To BAS-412A/BAS-416A/BAS-423A Users:

Thank you very much for purchasing a BROTHER embroidery machine BAS-412A • 416A • BAS-423A. The most up-to-date information must be added in the instruction manual for the machine you are using. Please refer to this corrigenda when reading the manual.

Replacing an adjusting the potentiometer assembly

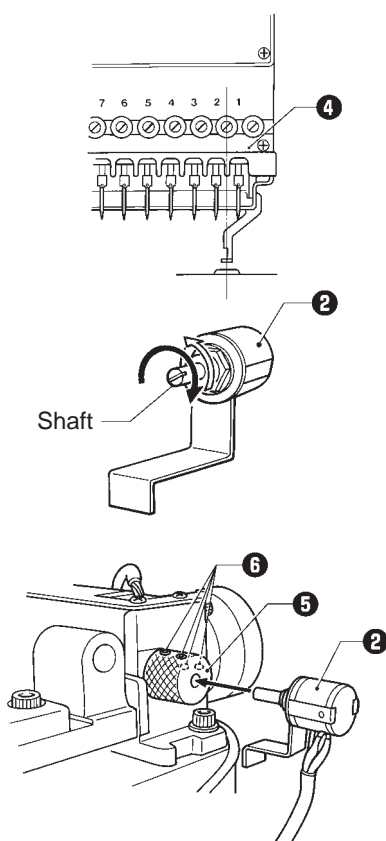
1. Connect the connector ③ of the potentiometer ② to the thread tension bracket circuit board ①.

Do not connect the potentiometer ② to the sewing machine at this time.

2. Turn on the sewing machine power.
3. Press the needle bar select key to display the needle bar selection screen.

4. Turn the knob ⑤ to move the needle bar case ④ so that the needle hole in the needle plate is in between needle bars No. 1 and No. 2.
5. Turn the shaft of the potentiometer ② clockwise as far as it will go so that 1 and 2 are flashing on the needle bar number display, and then turn the shaft counterclockwise until only 2 is flashing.
6. In this condition, insert the shaft of the potentiometer ② into the knob ⑤ so that it does not move, and secure by tightening the set screw ⑥.
7. Move the needle bar case ④ to the neutral position turn the knob ⑤ (the position where the needle bar case ④ does not move).
8. Check that the needle bars match the numbers in the display (No. 1 to No. 9) when the keys are used to move the needle bar case ④.
9. Once the operation has been checked and is okay, securely tighten the potentiometer ② set screws ⑥.
